LOCAL PLANNING PANEL MEETING

2 DA/124/2021/A - SECTION 4.55(2) - ALTERATIONS AND ADDITIONS TO CHESALON NURSING HOME - 144-146 BEECROFT ROAD, BEECROFT

DA No:	DA/124/2021/A (Lodged on 16 March 2023)
Description:	Section 4.55(2) application to modify the approved alterations and additions to an existing residential aged care facility
Property:	Lot 15 DP 6280, Lot 16 DP 6280, Lot 17 DP 6280, Lot 34 DP 6280 - Chesalon Nursing Home, No. 144-146 Beecroft Road, Beecroft
Applicant:	DJ Thompson Pty Ltd
Owner:	DJ Thompson Pty Ltd
Estimated Value:	\$12,440,447
Ward:	C Ward
Clause 4.6 Request:	N/A
Submissions:	4
LPP Criteria:	The modified development contravenes a development standard by more than 10%
Author:	Katrina Maxwell, Senior Town Planner
COI Declaration:	No Council staff involved in the assessment of this application have declared a Conflict of Interest.

Figure 2: Extract of southern elevation showing approved roofline in blue, and amended roofline in grey

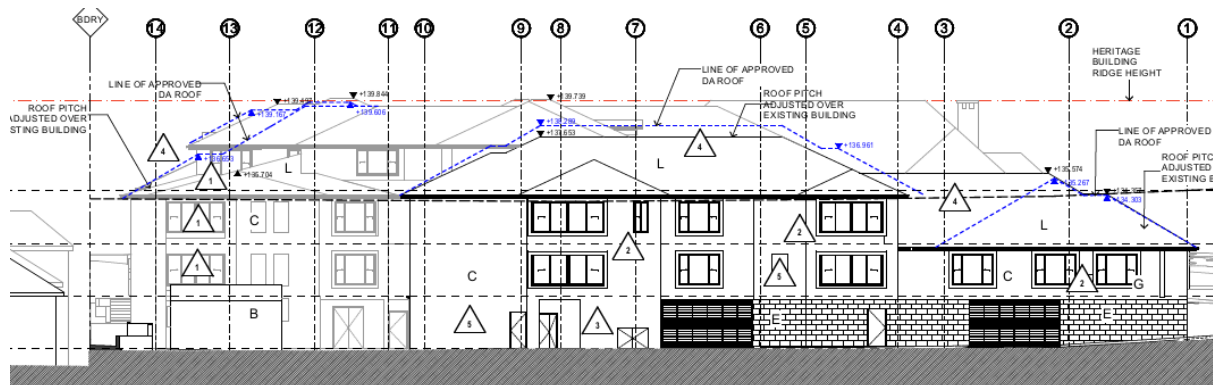
The modified development under this Section 4.55(2) would not exceed the approved building height of 12.5m, however the height contraventions are located within different sections of the roof (refer to Figures 2 and 3 below).

The approved development (DA/124/2021) has a height of 12.5m, equating to a contravention of 4m to the maximum building height requirement of 8.5m (47% contravention of the Height of buildings development standard). The modified development under this Section 4.55(2) application reduces the height of some of the building elements and increases the height of the central building element. However, the amended development does not exceed 12.5m in height at any point within the development.

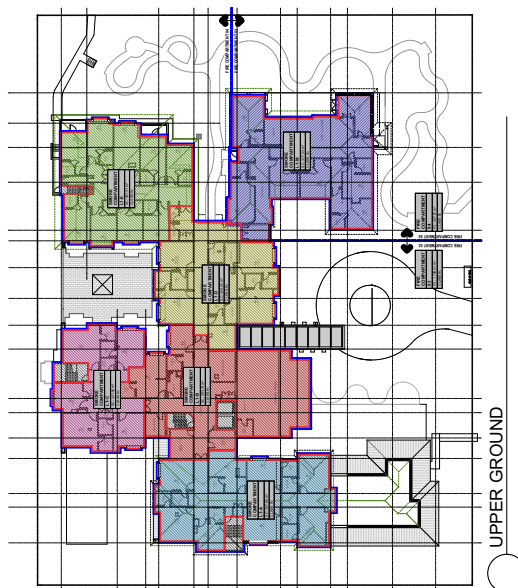
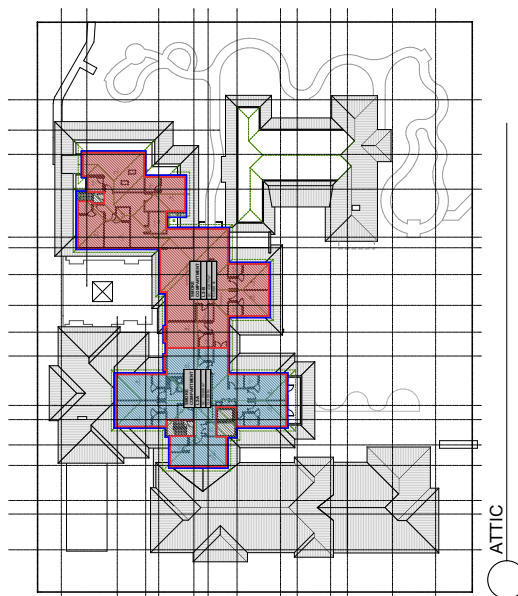
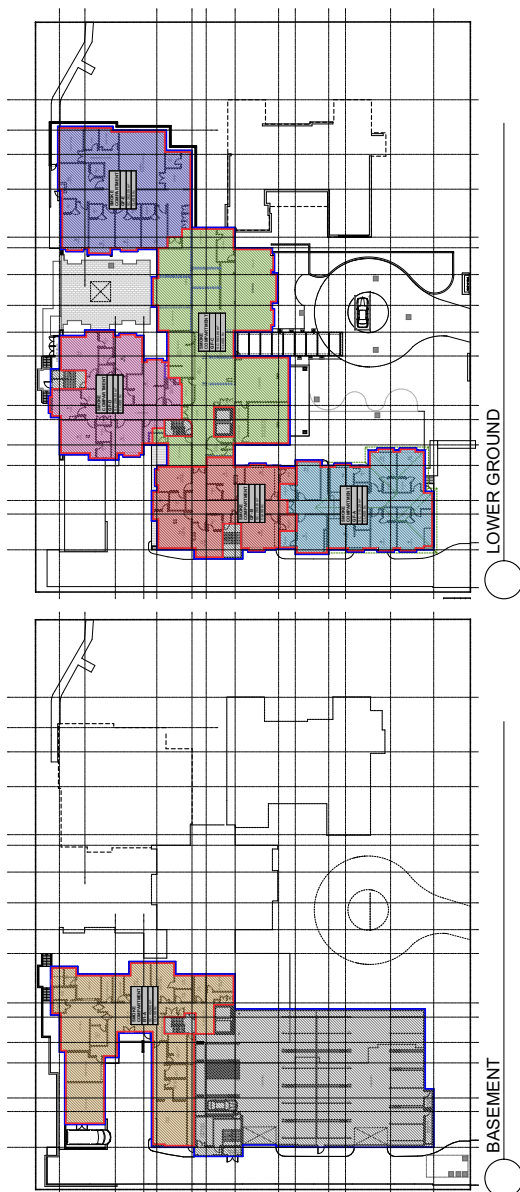
- Any entry door should be in the vehicle parking area as shown in Drawing A-16 to minimise any noise emanated towards our premises

- However, there are conflicts in the Master Plan Drawings plans provided. Drawing A-02 shows the entry door to the A/C Plant Room to the rear (facing our boundary) whereas Drawing A-12 and A-16 show the entry door toward the vehicle parking space.

Comment: Amended elevation plans were submitted which removed unnecessary colour and fences, making the plans easier to read. Sufficient detail has been provided to enable a thorough and accurate assessment by Council assessment officers. The amended elevation plans were published on Council's website to enable the public to view them, and the author of this submission was provided with hard copy of the plans to assist with viewing the proposed amendments.
